CR184 – Side Stand Replacement

Multistrada 1260 MY 2018 (All versions, Enduro Model Excluded)

Safety Recall Campaign SRV-RCL-19-004

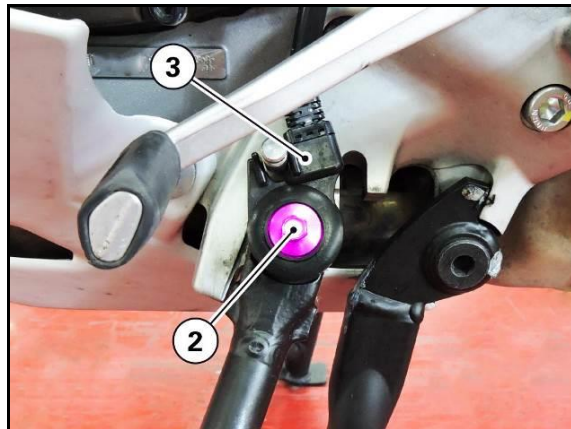
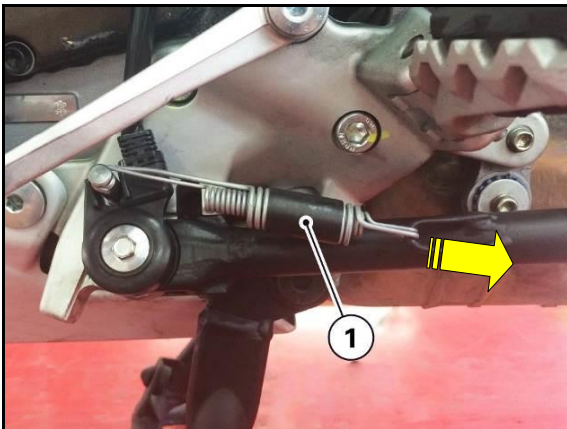
1. Position the bike on the central stand (if installed) or on the rear stand
2. Release the **2 return springs (1)** of the side stand from the relevant supports
3. Remove **screw (2)** that retains the side stand **switch (3)**

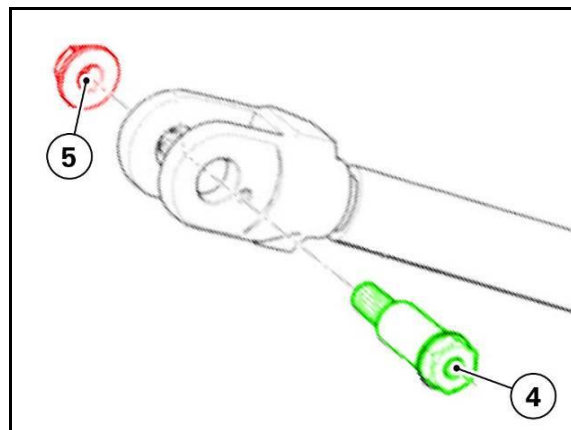
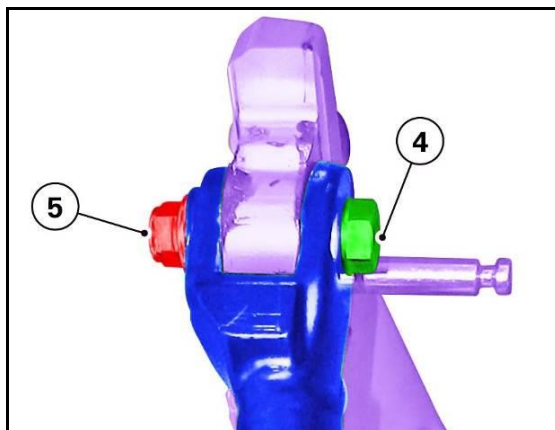
4. Remove **nut (5)** and **pin (4)** M8x1.25 that retains the side stand; then slide the side stand out

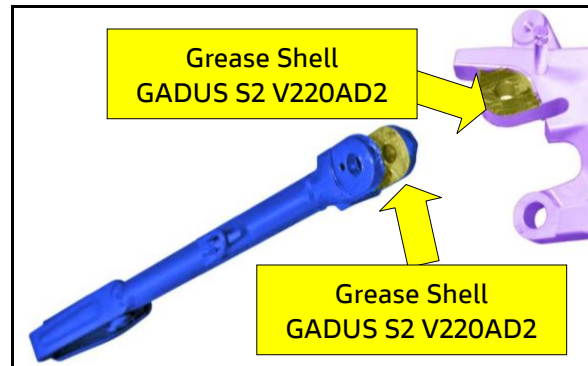
5. Take the new side stand and apply Shell GADUS S2 V220AD2 grease to the mating surfaces as shown in the figure

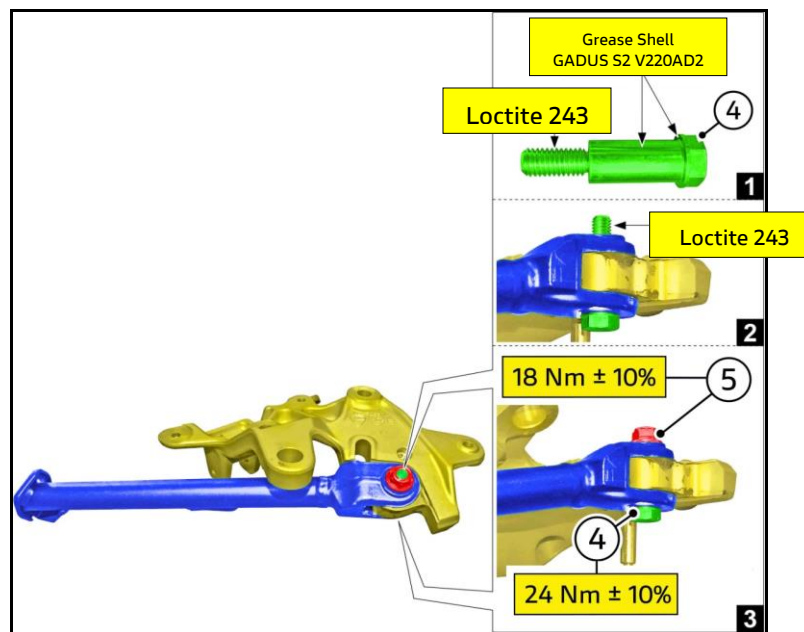
6. Apply Loctite 243 (or equivalent medium strength thread locking compound) to the threading and Shell GADUS S2 V220AD2 grease (or equivalent) to the underhead and cylindrical section of **pin (4)**, as shown in the figure
7. Fit the new side stand to the plate, aiming it as shown in the figure and secure it in place by starting **pin (4)**
8. Tighten **pin (4)** to **24 Nm ± 10%**
9. Apply Loctite 243 (or equivalent medium strength thread locking compound) along the **pin (4)** threading
10. Start **nut (5)** and, making sure that side stand is in "folded" position, tighten it to **18 Nm ± 10%**

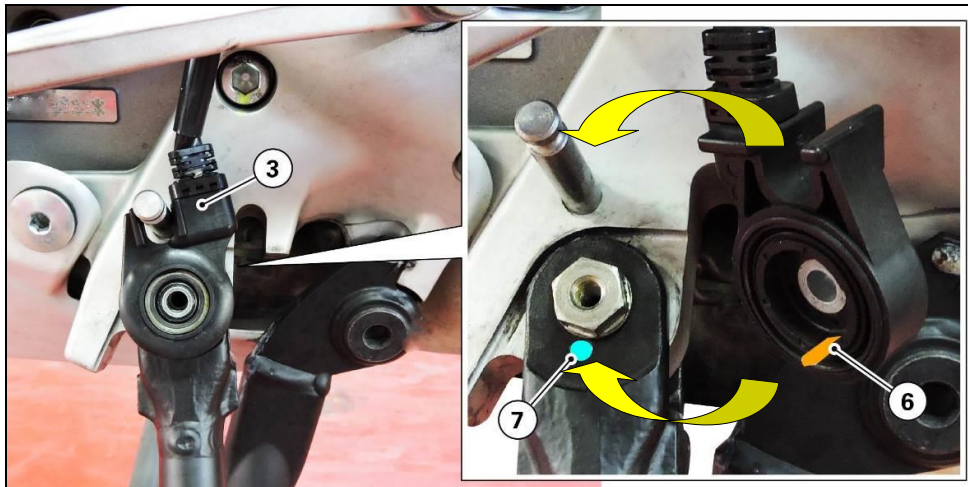
11. Install **switch (3)** on the side stand as shown in the figure

Ensure to properly insert the **timing pin (6)** of switch (3) in hole (7) of the stand

12. Tighten the retaining screw (2) to **5 Nm ± 10%**

13. Fit the **2 return springs (1)** of the side stand in the relevant supports

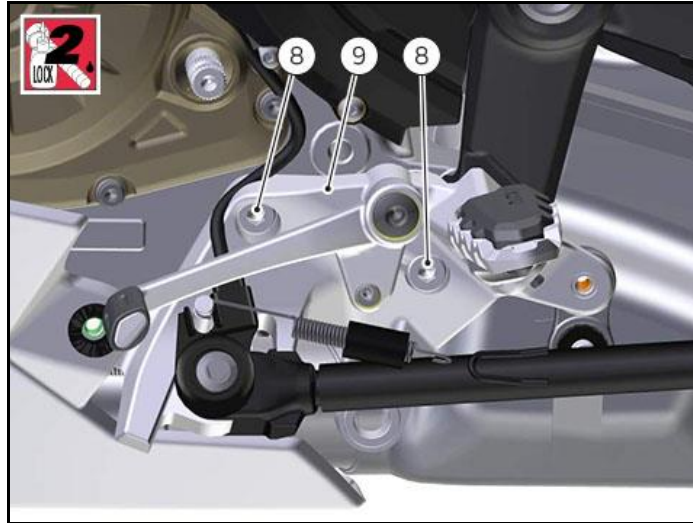
14. Check the torque at the 2 mounting bolts (**8**) for the side stand support bracket to **43 Nm** **± 10%**

15. If bolts turn during torque check, remove both bolts 1 at a time, apply Loctite 243 (or equivalent medium strength thread locking compound), reinstall, and torque to **43 Nm** **± 10%**
16. Check that the side stand moves freely
17. Check the correct operation of the safety switch
